COMMITTEE OF THE WHOLE NOVEMBER 3, 2008

ZONING BY-LAW AMENDMENT FILE Z.06.068 DRAFT PLAN OF SUBDIVISION FILE 19T-06V14 MOLISE KLEINBURG ESTATES INC. REPORT #P.2007.4

Red-Lined Draft Plan 19T-06V14

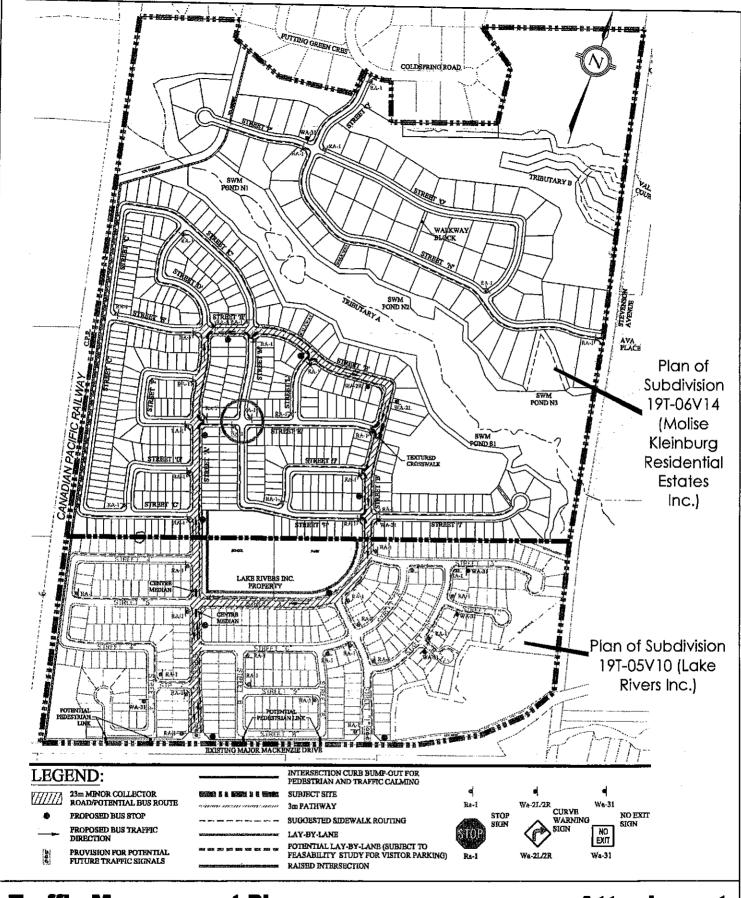
The draft plan has been red-lined, as shown on Attachment #3, to incorporate the following changes:

- The addition of Block 537 at the northeast corner of the subject lands for the purpose of a Sanitary Pumping Station
- Block 453 shall be shown on the plan as 9m wide
- Provide a 5m x 5m daylight triangle and associated 0.3m reserve at the intersection of Street "Q" and Coldspring Road as per City Standard, Drawing D-1
- Remove 3m wide multi-use pathway along Park Block 460
- Minimum Curb Radius on the 2 cul-de-sacs on the plan shall be R=15
- Typical detail for all angle bends should be as per City Standard C4

- 1. The Plan shall relate to the Draft Plan of Subdivision, prepared by Matthews Planning & Management Ltd., dated September 29, 2008, as red-lined on November 3, 2008, to incorporate the following revisions:

- The addition of Block 537 at the northeast corner of the subject lands for the purpose of a Sanitary Pumping Station
 - Block 453 shall be shown on the plan as 9m wide

- Provide a 5m x 5m daylight triangle and associated 0.3m reserve at the intersection of Street "Q" and Coldspring Road as per City Standard, Drawing D-1

- Remove 3m wide multi-use pathway along Park Block 460
 - Minimum Curb Radius on the 2 cul-de-sacs on the plan shall be R=15
 - Typical detail for all angle bends should be as per City Standard C4
